ARCHITECT'S SUPPLEMENTAL INSTRUCTIONS

PROJECT:	Roosevelt Lofts Historic Rehabilitation San Angelo, TX	Report No.	Five (5)
OWNER:	Overland Property Group 234 N. Santa Fe Ave, Suite A Salina, KS 67401	Date	June 5, 2024
CONTRACTOR:	MCP Group 3501 SW Fairlawn Rd. Topeka, KS 66614	Architect's Proj No.	22-3281
		Contract For:	General Construction Mechanical, Electrical

DESCRIPTION:

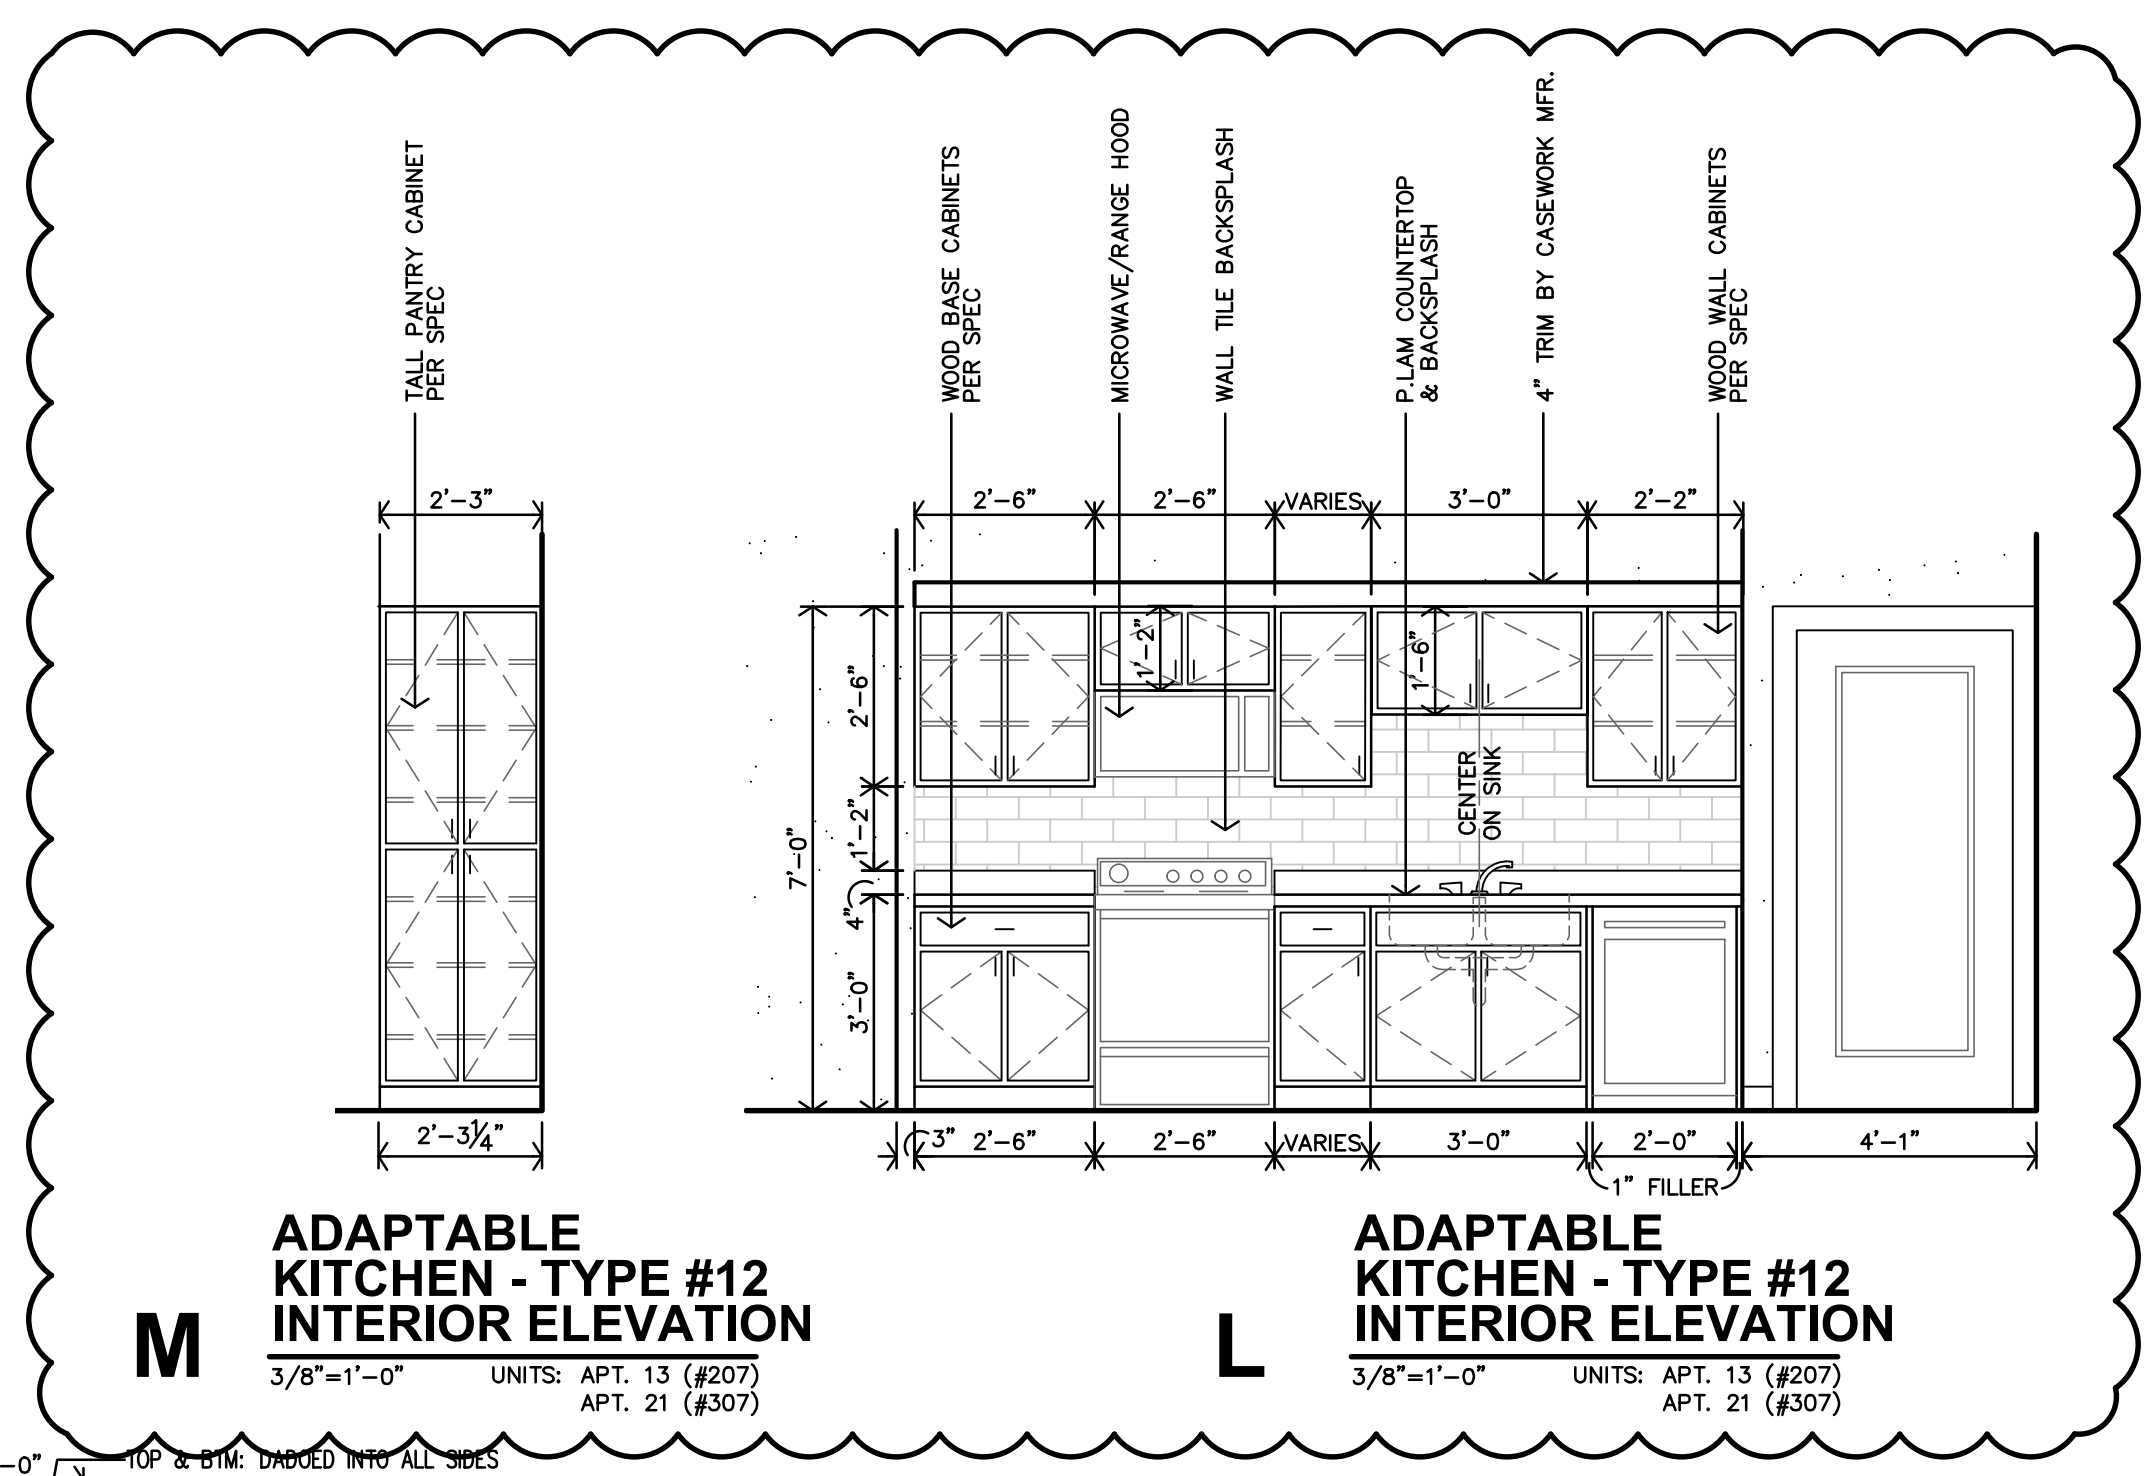
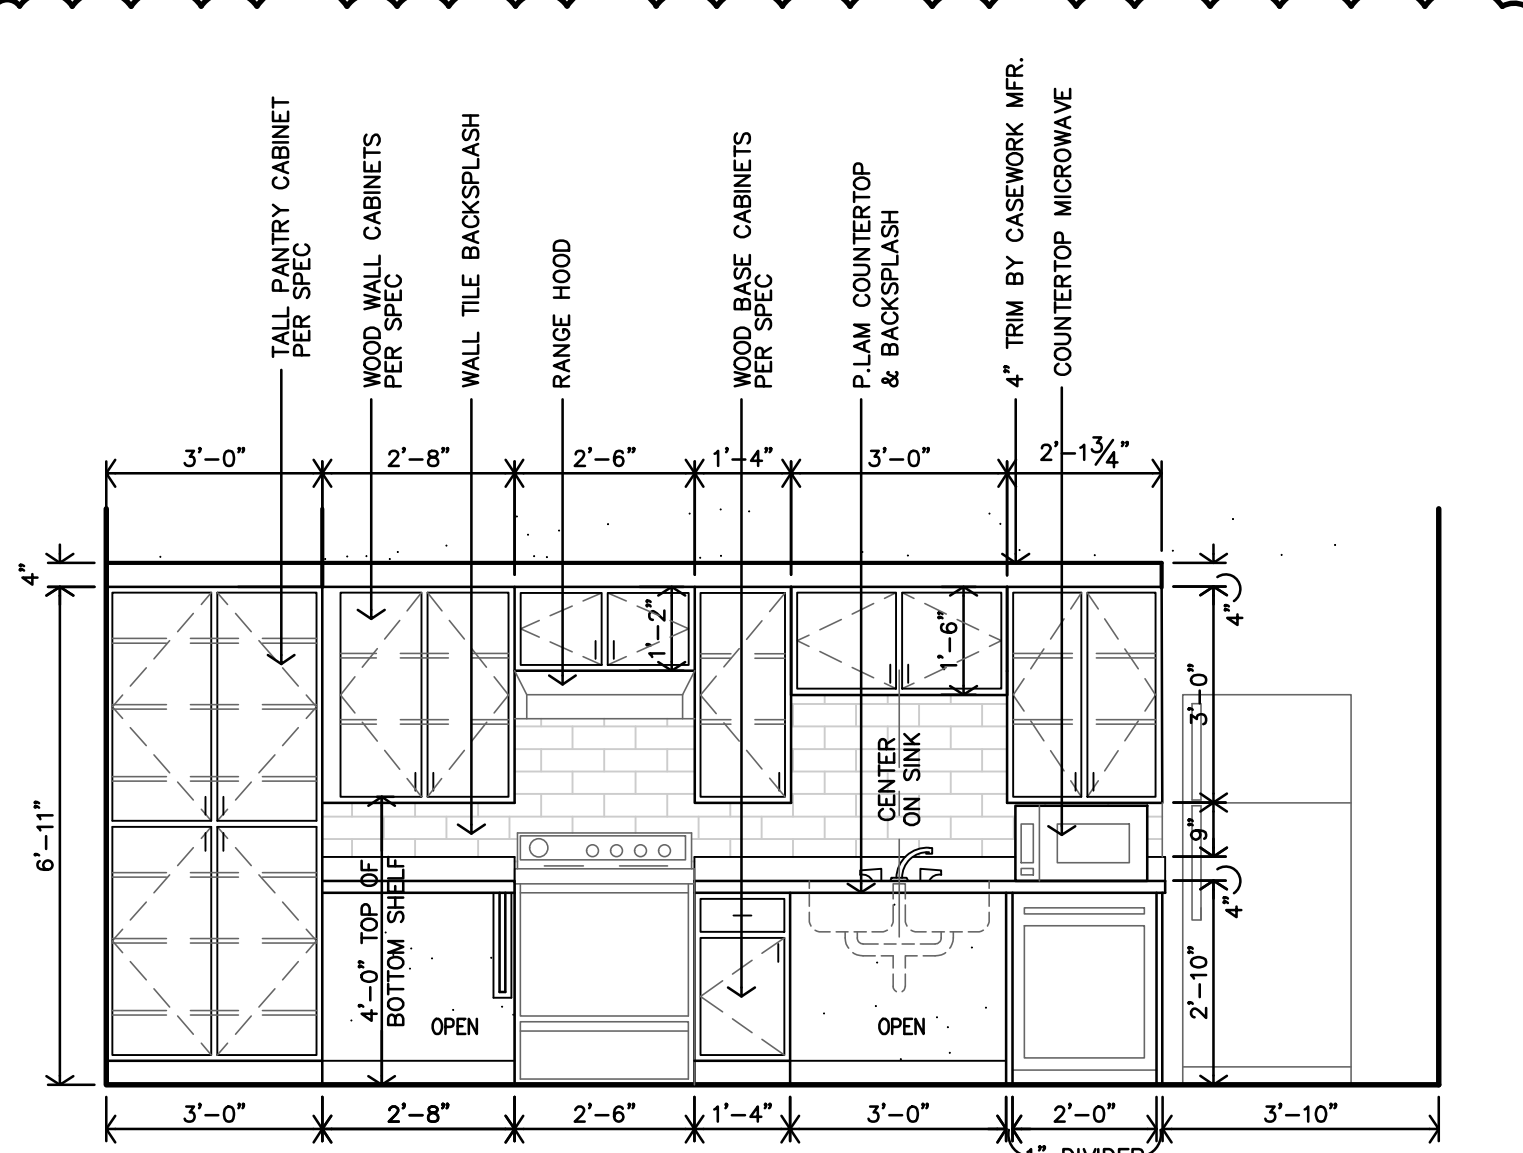
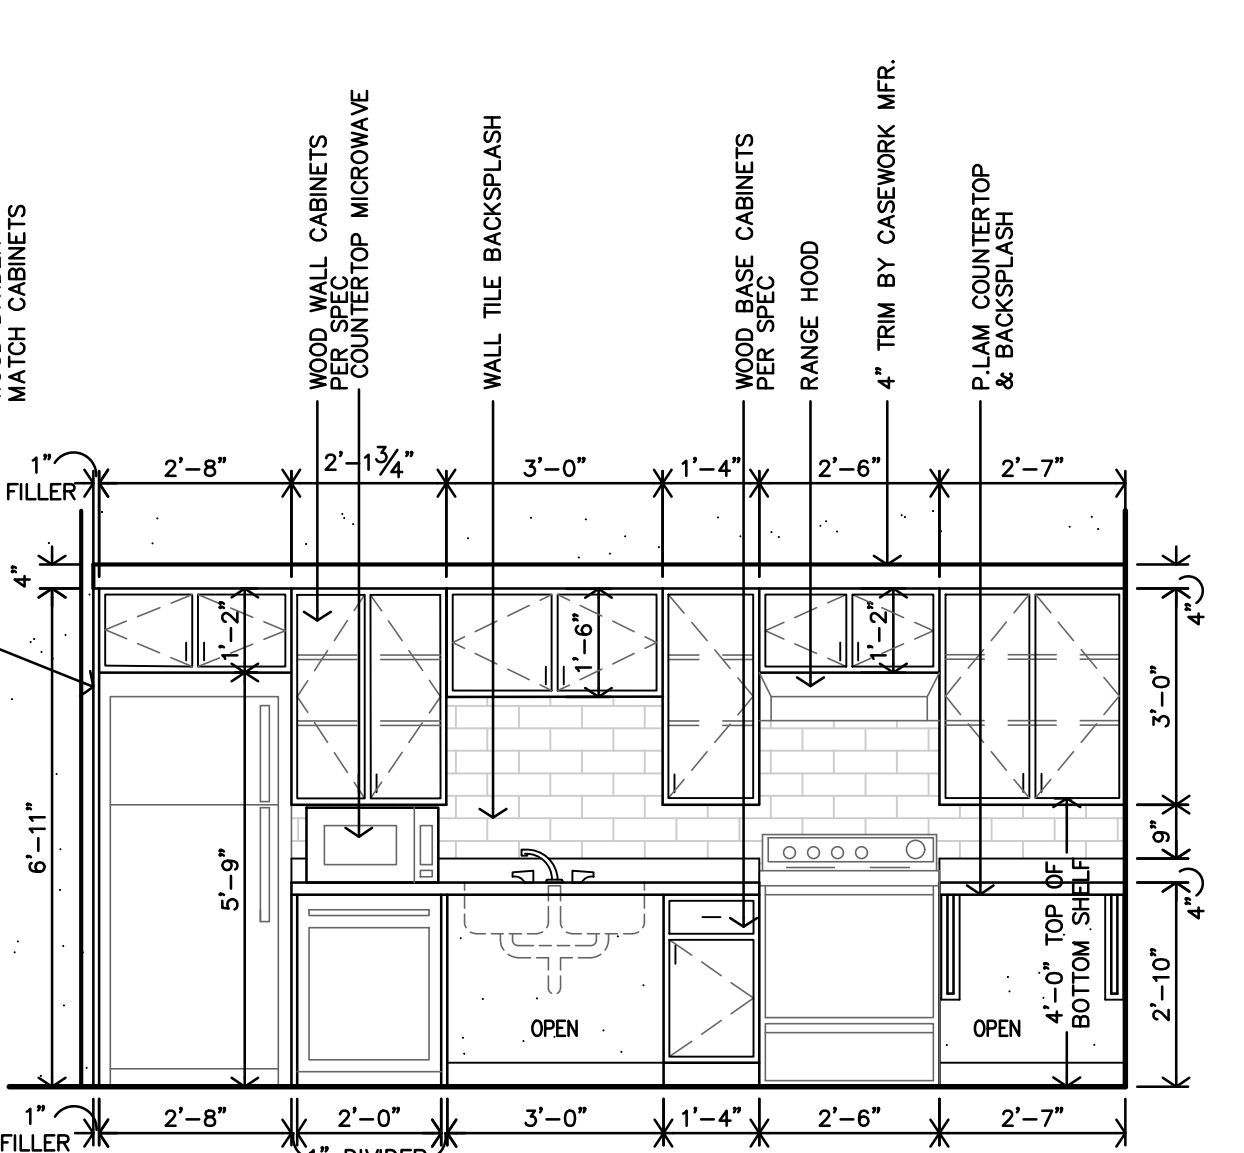
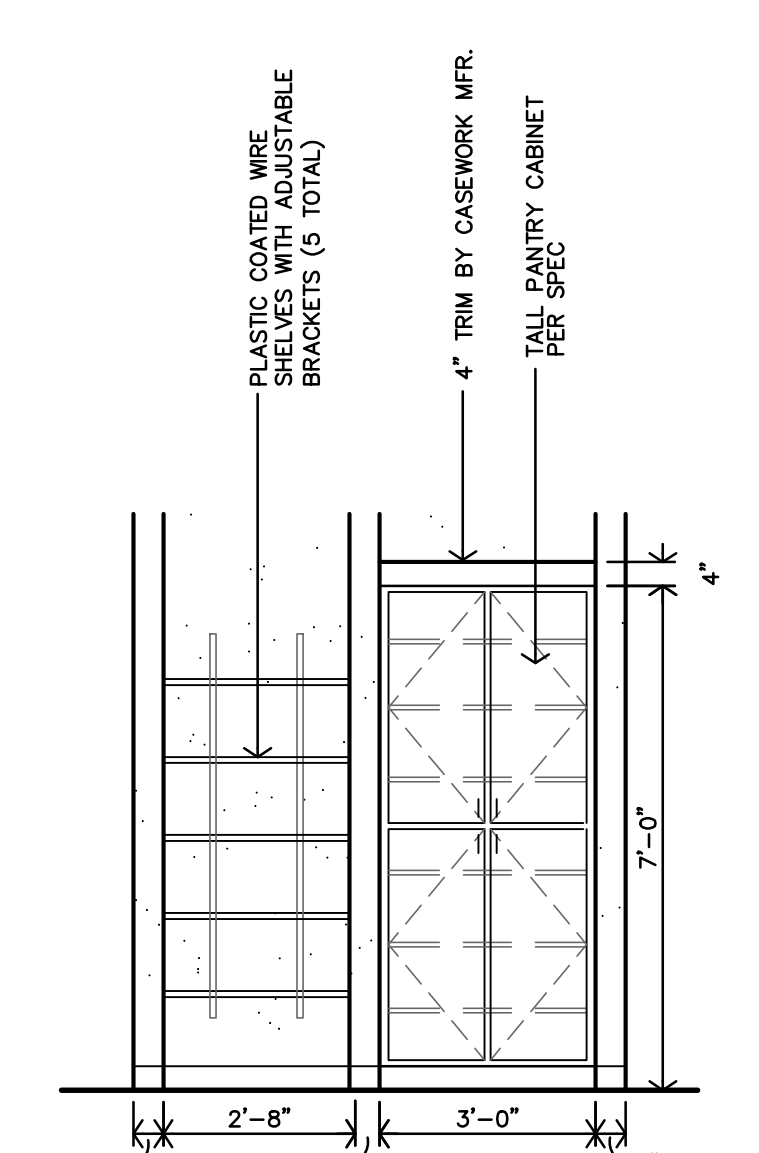
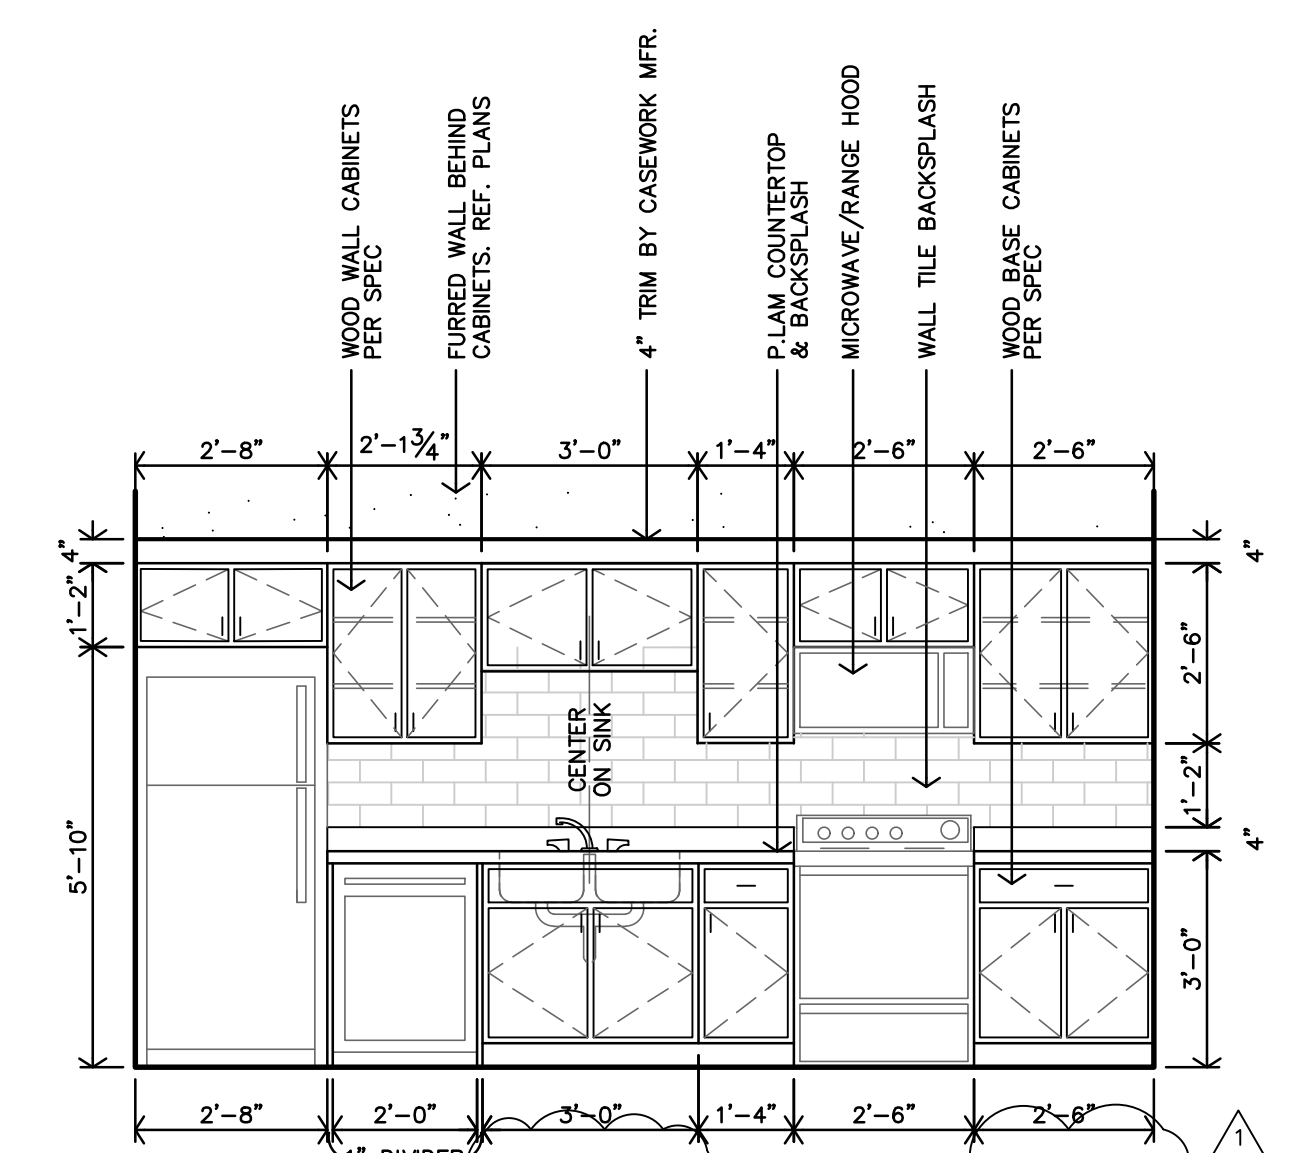
2. Apartment 13 (Rm #207) – Kitchen casework, fixtures, appliances, closet & shelves have been arranged to avoid a conflict between the entry door clearances and the refrigerator. Reference revised sheets A2.5, A9.5, A7.2, M1.9, E1.3, E1.10

3. Apartment 21 (Rm #307) - Kitchen casework, fixtures, appliances, closet & shelves have been arranged to avoid a conflict between the entry door clearances and the refrigerator. Reference revised sheets A2.7, A9.5, A7.2, M1.9, E1.3, E1.12
